SUNDRY NOTICES AND REPORTS ON WELLS

Chaco 23-08 3

Energen Resources would like to make the following changes to the Chaco 23-08 3 #1H.

Drilling Plan
Energen Resources Corporation
Revised 10/13/15

Plan: APD Plan #2

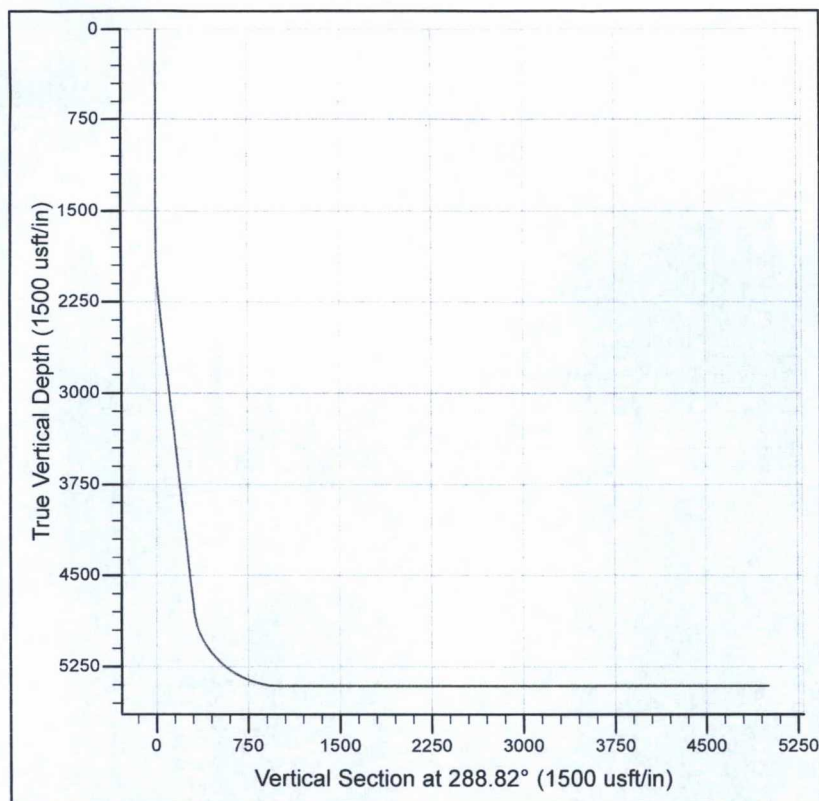
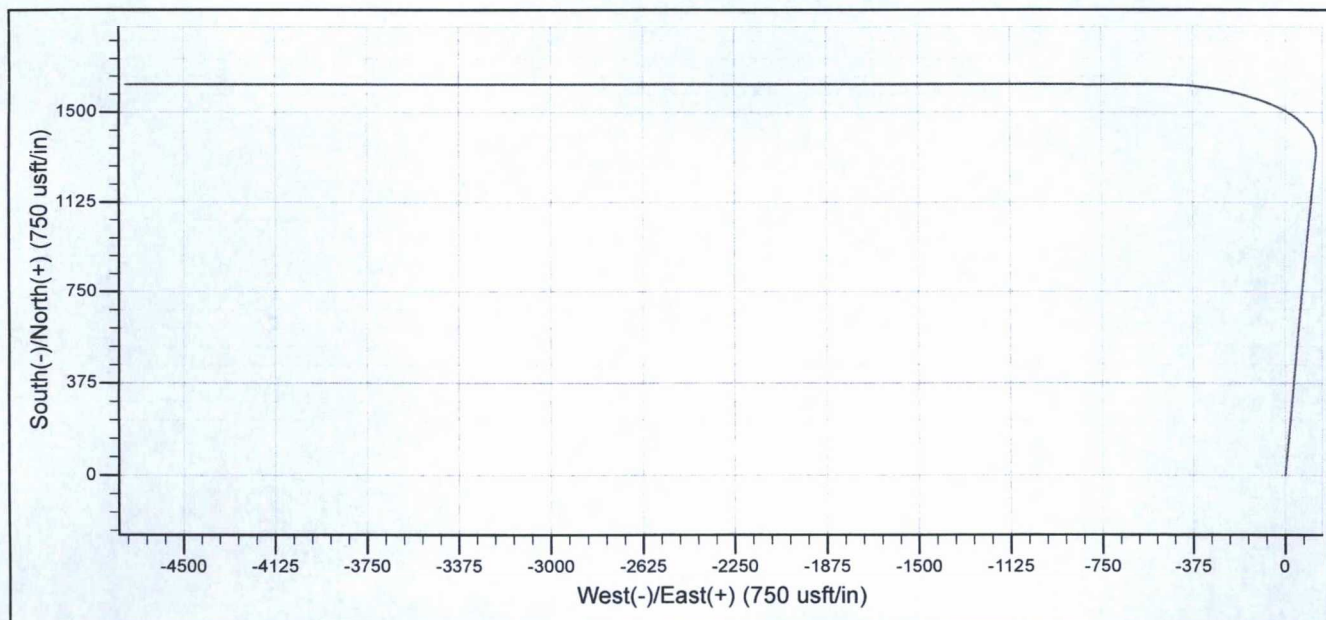
The revised drilling and directional plans are attached.

Sec	MD	Inc	Azi	TVD	+N/-S	+E/-W	Dleg	TFace	VSect
1	0.0	0.00	0.00	0.0	0.0	0.0	0.00	0.00	0.0
2	1750.0	0.00	0.00	1750.0	0.0	0.0	0.00	0.00	0.0
3	2319.9	25.65	5.29	2301.1	124.9	11.6	4.50	5.29	29.3
4	5112.7	25.65	5.29	4818.7	1328.5	123.1	0.00	0.00	311.9
5	6138.1	90.00	270.00	5416.0	1614.0	-513.0	9.00	-94.78	1006.1
6	10362.1	90.00	270.00	5416.0	1614.0	-4737.0	0.00	0.00	5004.4
